## **ARCHITECTURAL REVIEW COMMITTEE MEMORANDUM**

DATE: JANUARY 3, 2022 NEW BUSINESS

SUBJECT: ALANA COFFIN, OWNER, REQUESTING A LAND USE PERMIT AND A WAIVER TO CONTINUE THE USE OF AN ENLARGED PARKLET LOCATED AT 368 NORTH PALM CANYON DRIVE, ZONE CBD, (CASE 21-083 LUP). (AP)

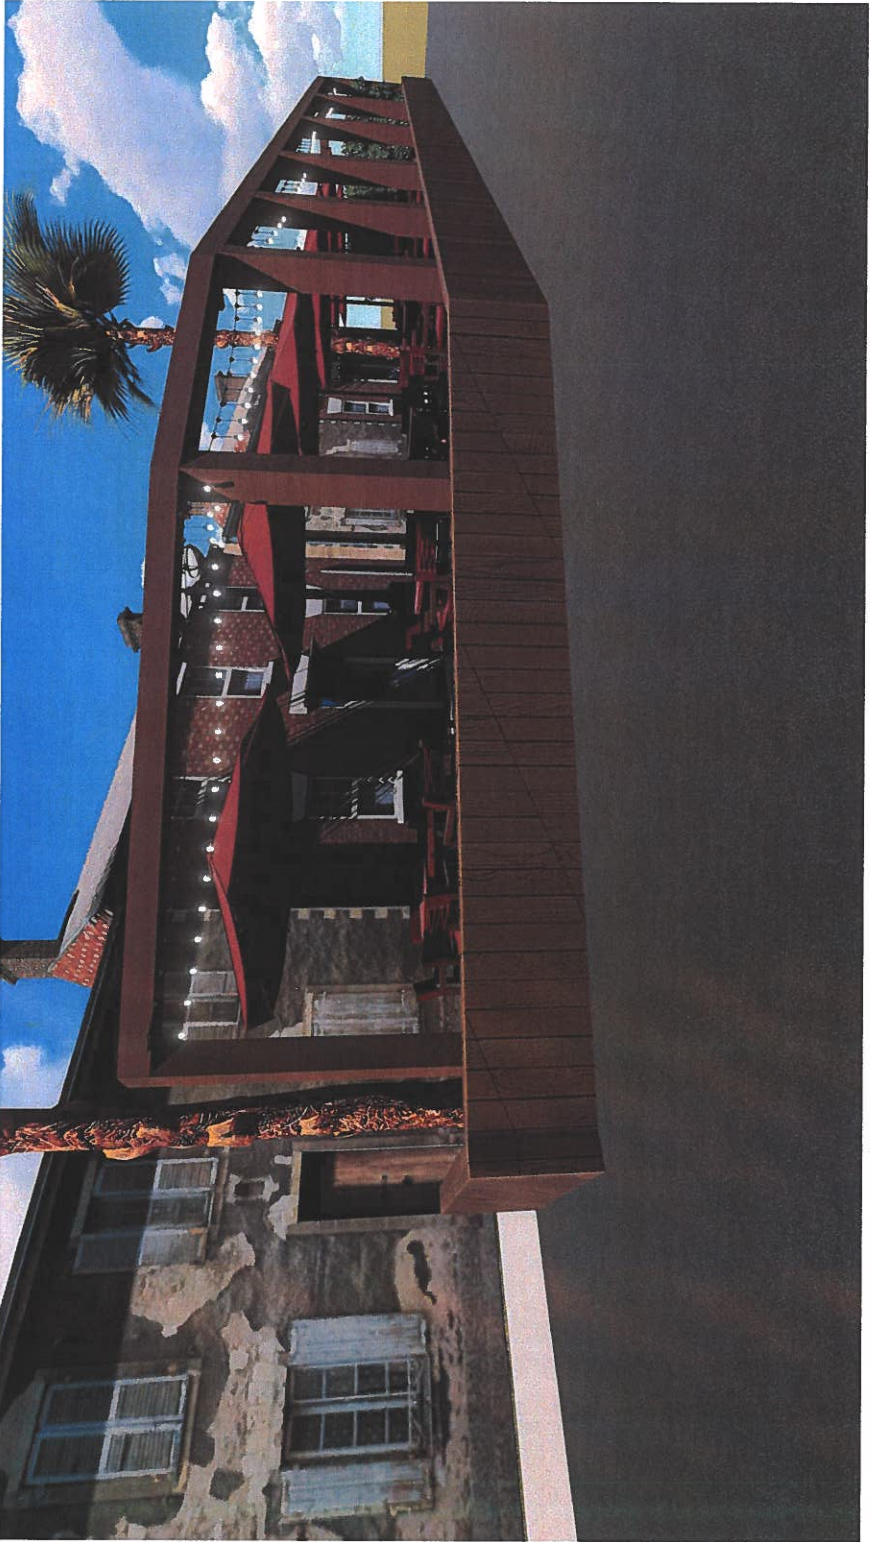
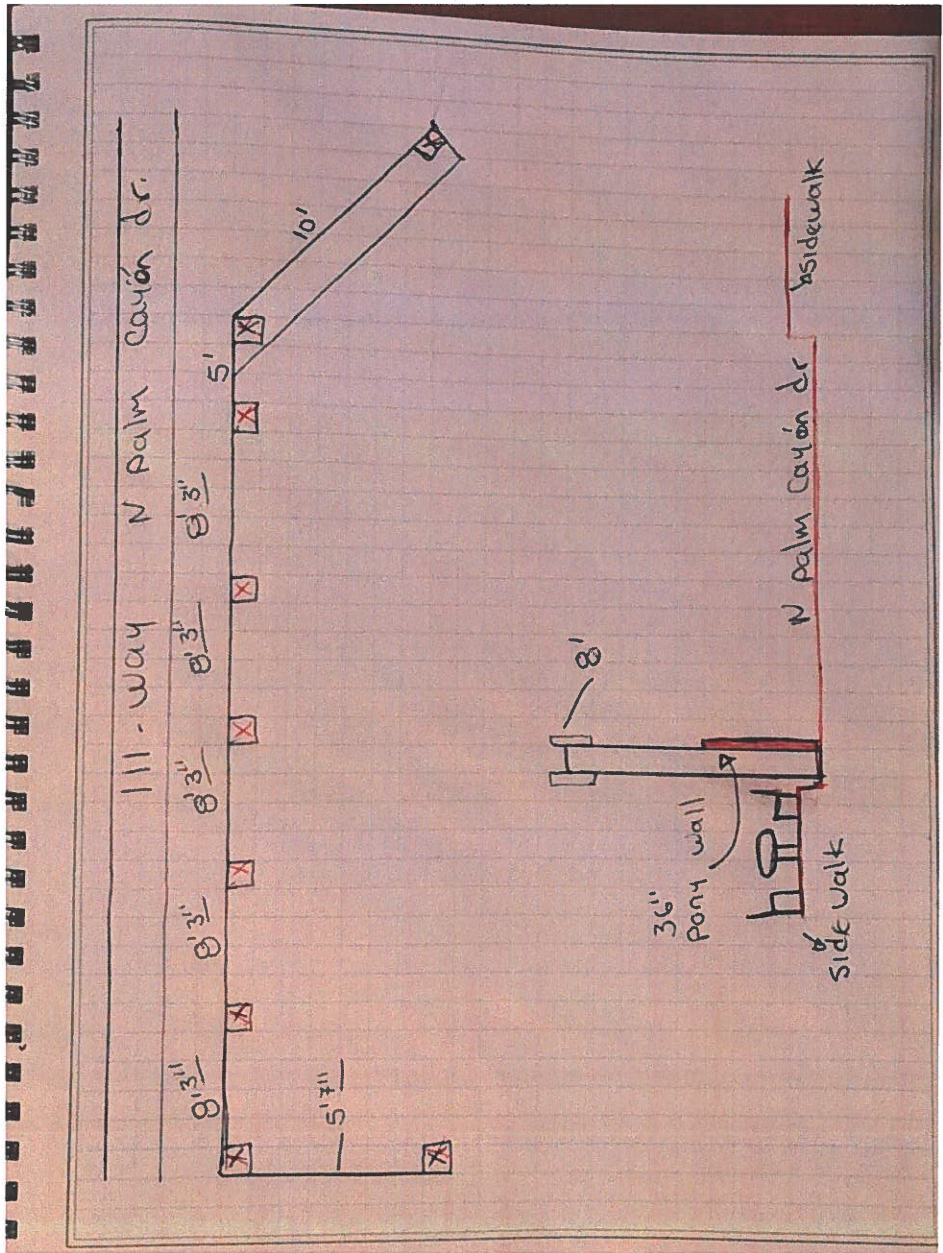
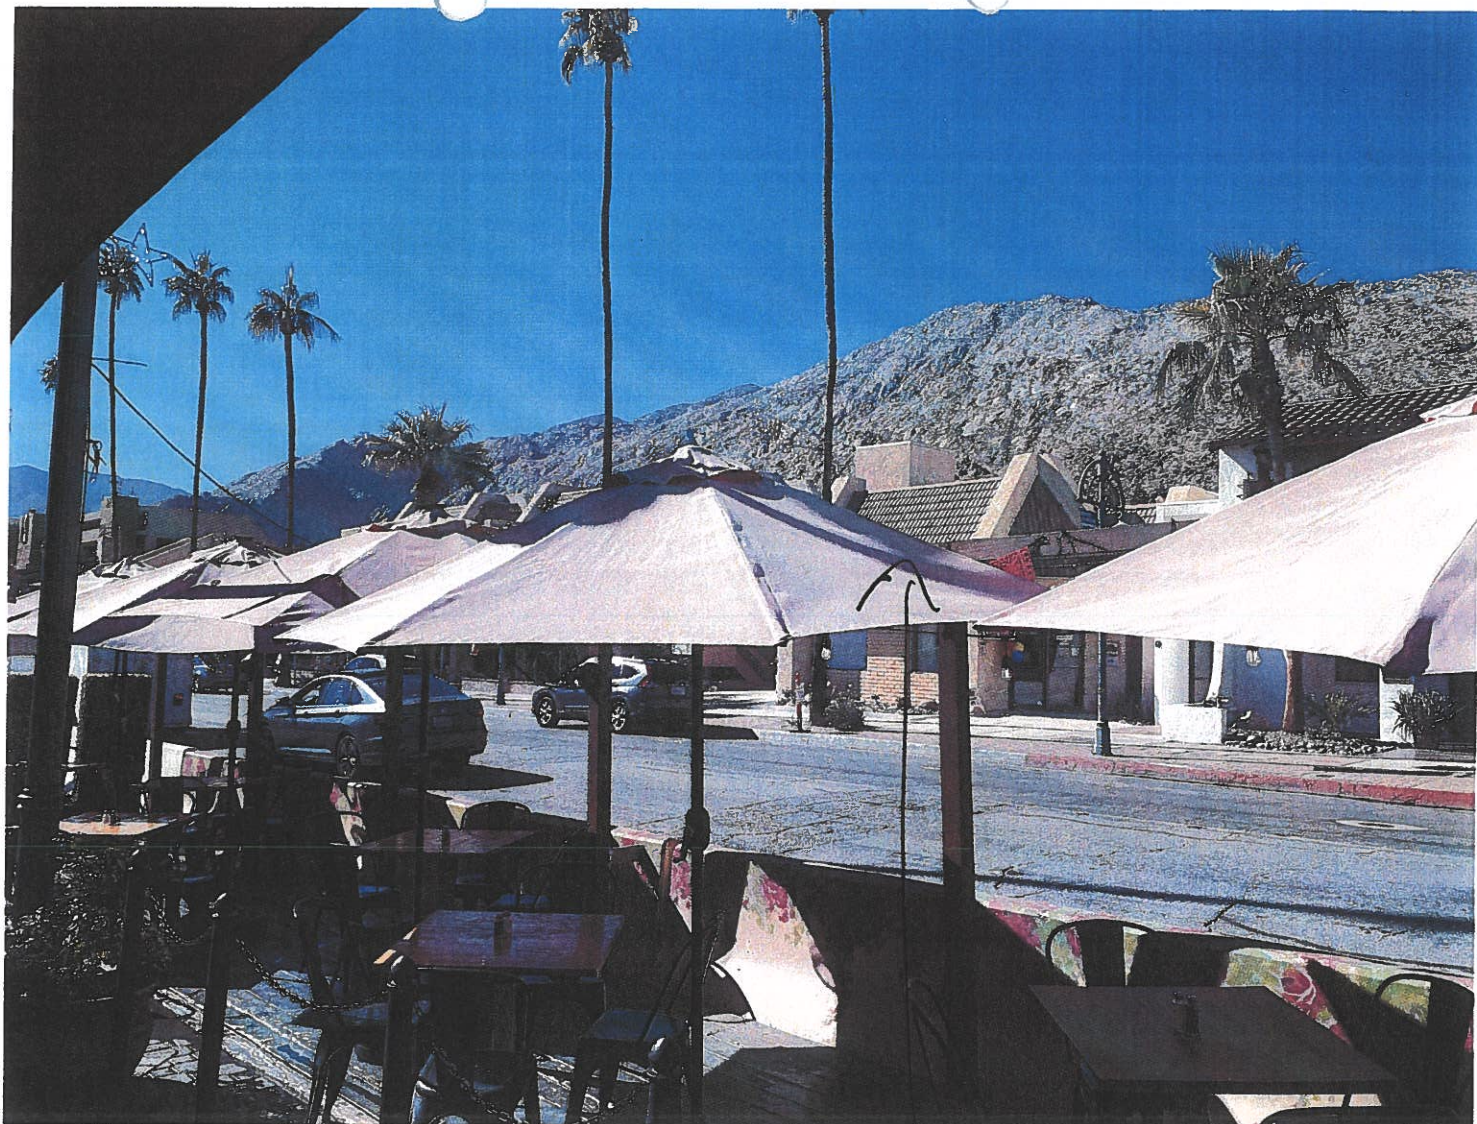
- 60-inch ped walkway reduced to 48-inch in certain sections due to raised concrete planter and entrancing.
- Use portable stanchions as ABC Dining Barrier for sidewalk dining.
- City to install K-Rails for Street Dining
- Allow drainage to flow through gutter, cannot be inhibited by platform placement.

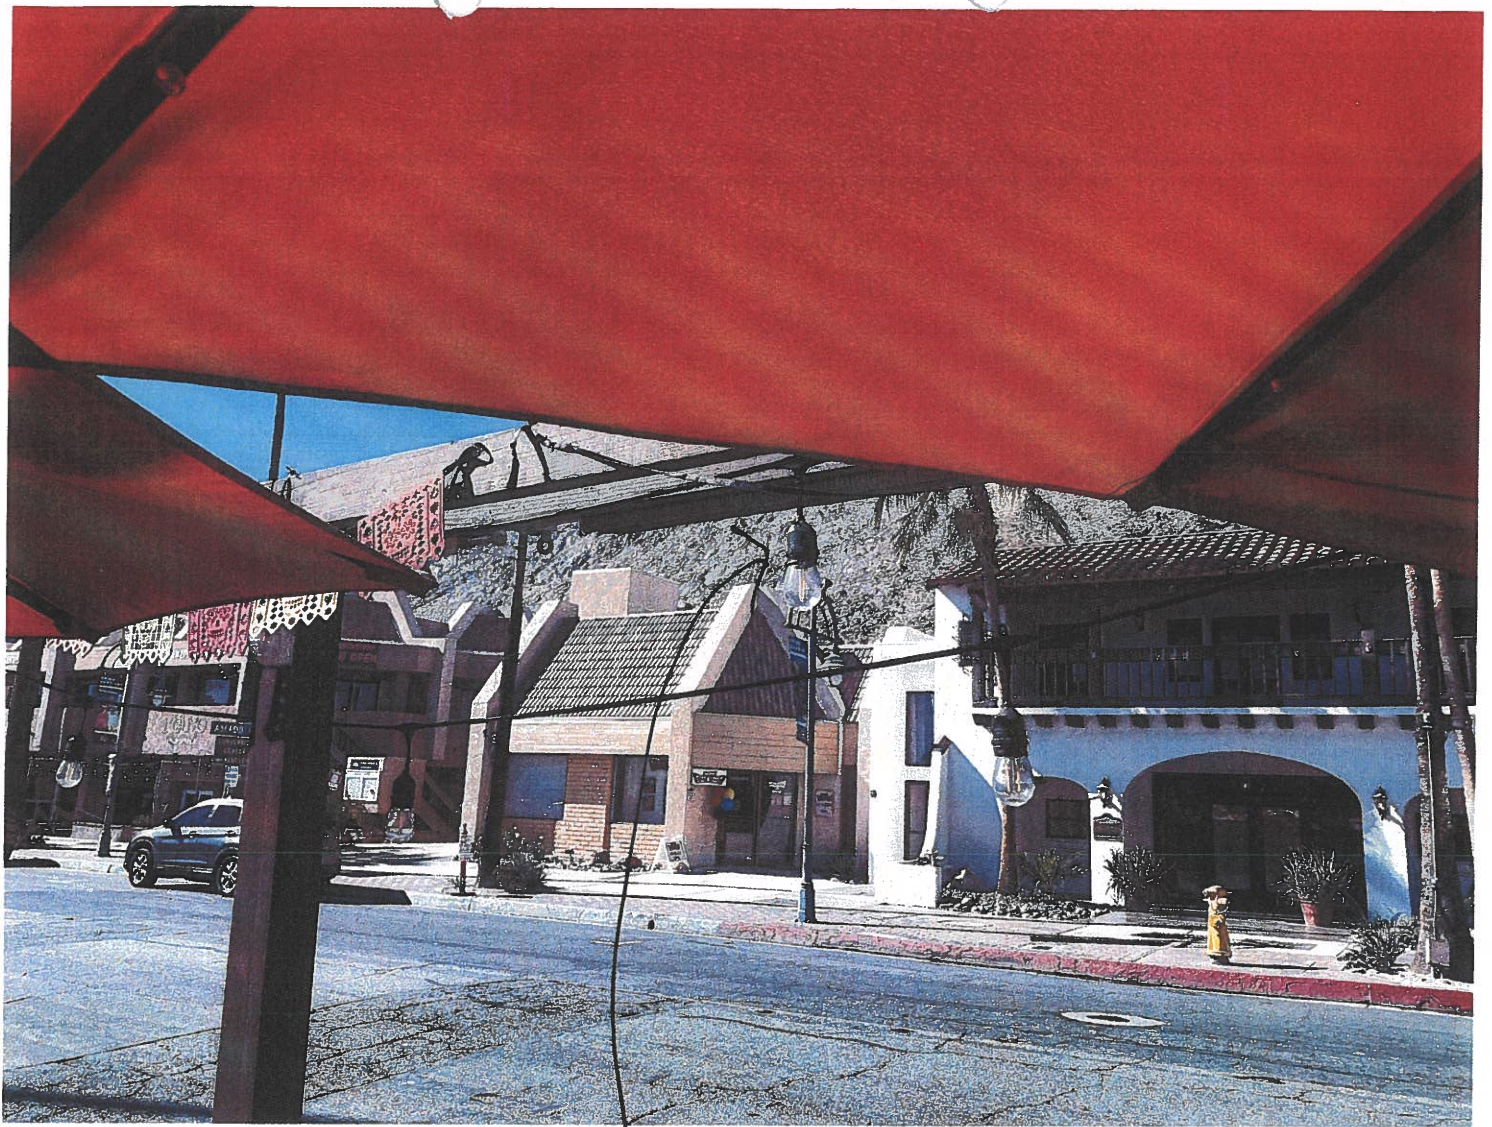
umbrellas consistent  
with color scheme

clear  
light  
bulbs

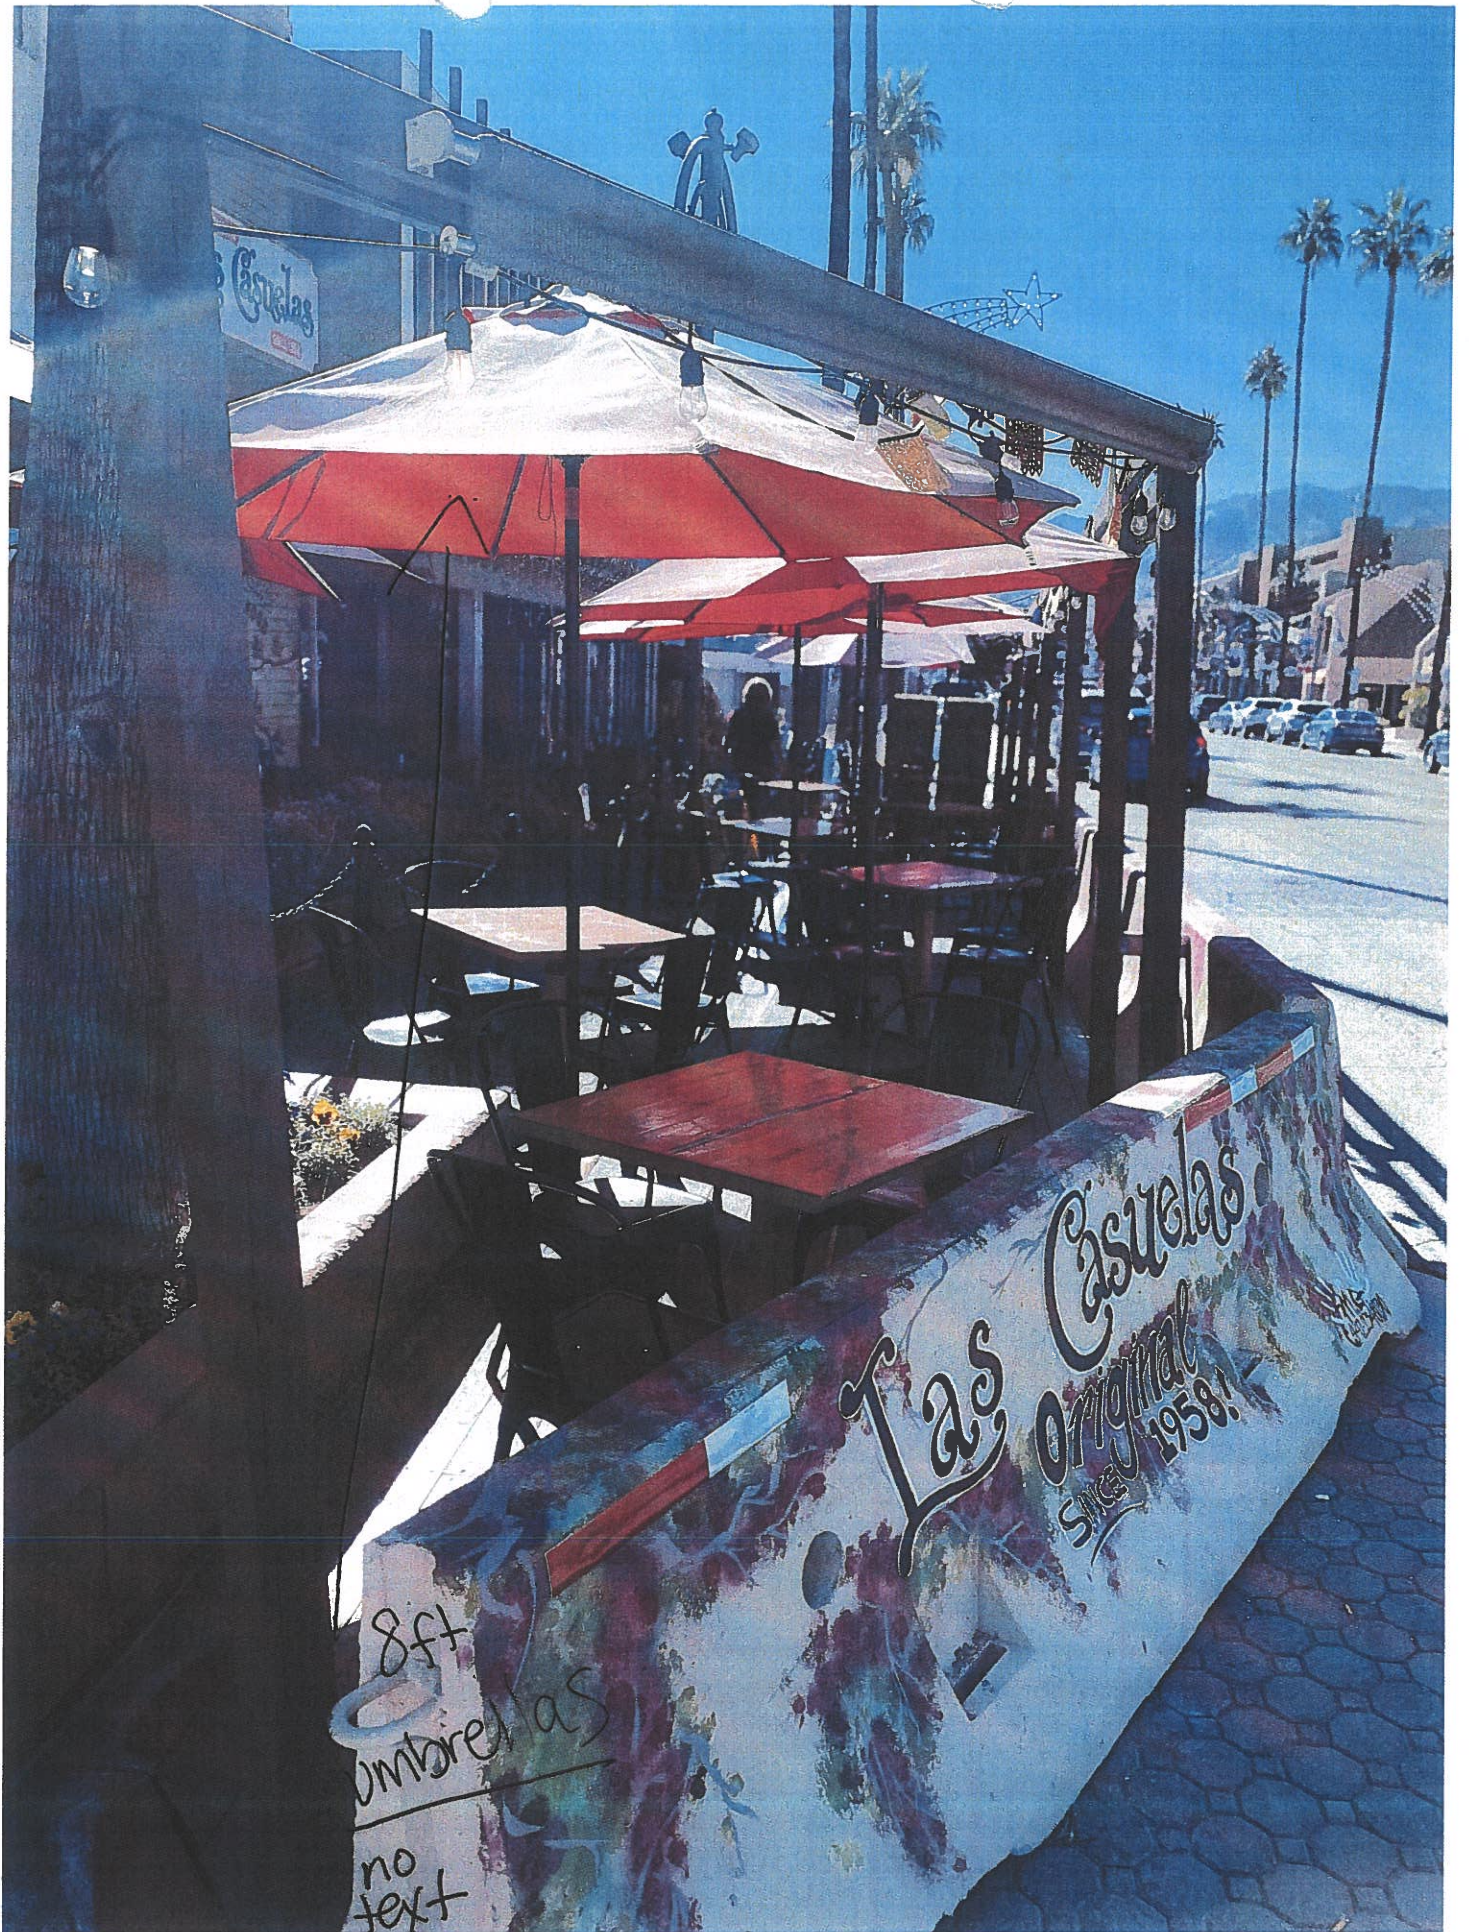
does not extend  
beyond tenant space

8ft  
umbrellas

no  
text
